**MAJOR PROJECT ASSESSMENT:**  
**Sydney Opera House Vehicle and Pedestrian Safety Project**  
**MP09\_0200 (MOD 2)**

Director-General's  
Environmental Assessment Report  
Section 75I of the  
*Environmental Planning and Assessment Act 1979*

February, 2013

Figure 4: Proposed Pedestrian Tunnel

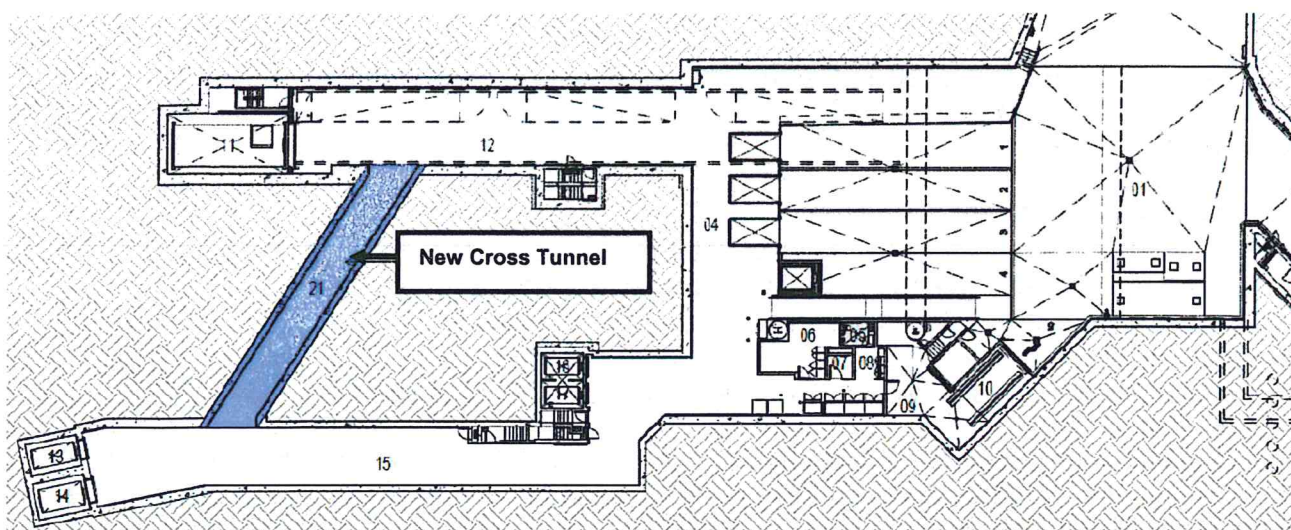
The additional pedestrian tunnel is proposed to provide an alternate egress route and improve back-of-house functionality during event bump-in and bump-out periods. In addition, the tunnel will allow for the movement of construction equipment between the Opera Theatre and Concert Hall corridors during the basement excavation works, and will provide the added benefit of reducing the length of the construction program by providing an alternate access route for the tunnelling equipment required to construct the new basement levels.

- The proposed cross tunnel at basement level B4 will have no adverse impacts on the heritage values of the site. Furthermore, the HIS notes that the tunnel may improve the functionality of
